14 Gideon Drive and 2012 Oxford Street West - Review of EIS prepared by MTE
Reviewers: S. Esan, S. Heuchan, S. Levin

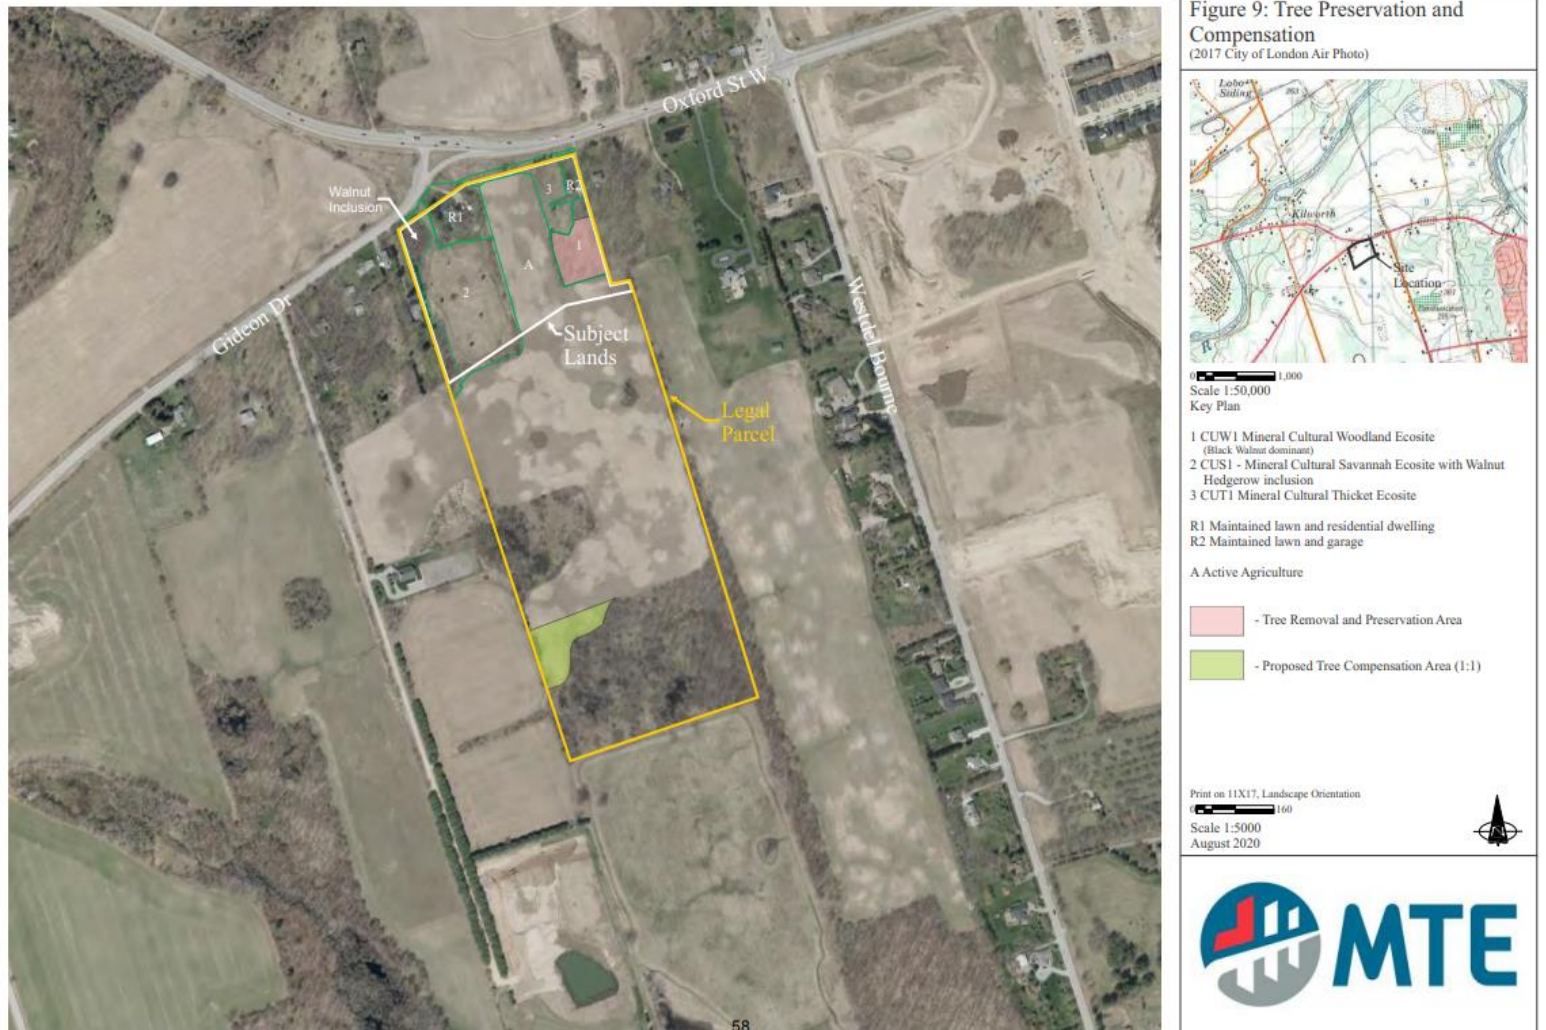
Walnut inclusion area is being lost to the proposed road. These trees being removed but not included as part of the compensation. (see Figures 8 and 9)

RECOMMENDATION #1: The compensation area shown in Figure 9 be increased to include the loss of the black walnut inclusion. Ideally, it would then allow a connection to the wet area to the north. See Figure 9 following:
